CCEC-26-002

Subject: Response to Request for Additional Information by the Office of Nuclear Reactor Regulation to support Review of TMI-1/ Crane (Cycle 22) Steam Generator Inspection Report

TMI-1/CRANE (CYCLE 22) STEAM GENERATOR INSPECTION REPORT

ENCLOSURE: Condition Monitoring and Operational Assessment of TMI-1 Steam Generators 2024 Inspection

Figure 4-3: TMI Distribution of Structural Lengths – Both SGs

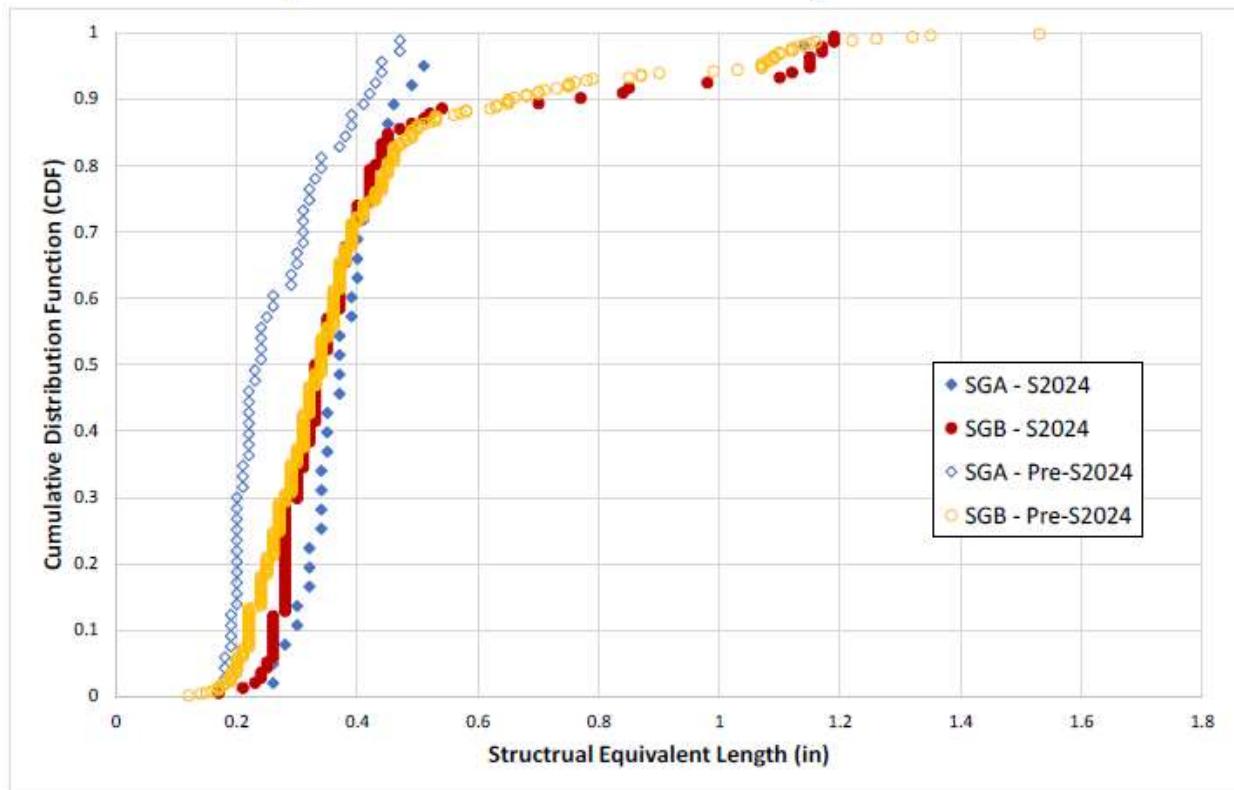
During the most recent operating cycle, two wear indications at broached tube supports in SG B grew from non-detectable to greater than 40 percent through-wall in one cycle. The deepest indication, sized as 47 percent through-wall, has a distinctly tapered wear shape. Discuss if other deep wear scar[s] that exhibited high growth from the previous inspection had flat wear or tapered wear. In addition, discuss how these higher growth indications are considered in the operational assessment for wear at broached support plates.

TSP wear flaws greater than or equal to 30% through wall depth (TWD), measured with the bobbin probe, were structurally profiled to establish the number of flat vs. tapered wear flaws and to determine if wear was occurring on multiple lands. The majority of the broached TSP wear indications had tapered flaw shapes, with the largest growth from a repeat indication also tapered. The deepest single flaw, SG B, R4-T1 at 12S, had a distinctly tapered profile resulting in a maximum depth of 45% TW and structurally equivalent depth of 38.7% as sized with Array. The figure below (Figure 4-3 taken from the 2024 CMOA) shows a distribution of structural lengths for the deepest flaws for both SGs. The population is tightly grouped up to approximately 0.5" in length, indicative of tapered wear, with flaws greater than 0.5" in length being flat or nearly flat.

It is noted that the flaws with the largest growth in 1R22 (2017) and largest depth from Array had tapered flaws (Tubes R5-T11 at 11S, R5-T14 at 11S, and R17-T74 at 11S). The largest new flaw and largest depth from bobbin in 1R22 (2017) were flat (Tubes R105-T3 at 14S and Tube R105-C4 at 15S).

When considering the operational assessment for SG B, support wear continues to be notably different inside vs outside a tube bundle radius of 48", therefore the bundle was treated as separate zones. In past analyses three zones were used: "Inner Bundle", "Broken Ring" and "W-axis" zones, since a large fraction of the tubes in the "W-axis" zone are now plugged, wear growth rates and new flaw depths were sufficiently similar such that combining the "Broken Ring" and "W-axis" into one "Outer Ring" zone simplified calculations while maintaining conservatism.
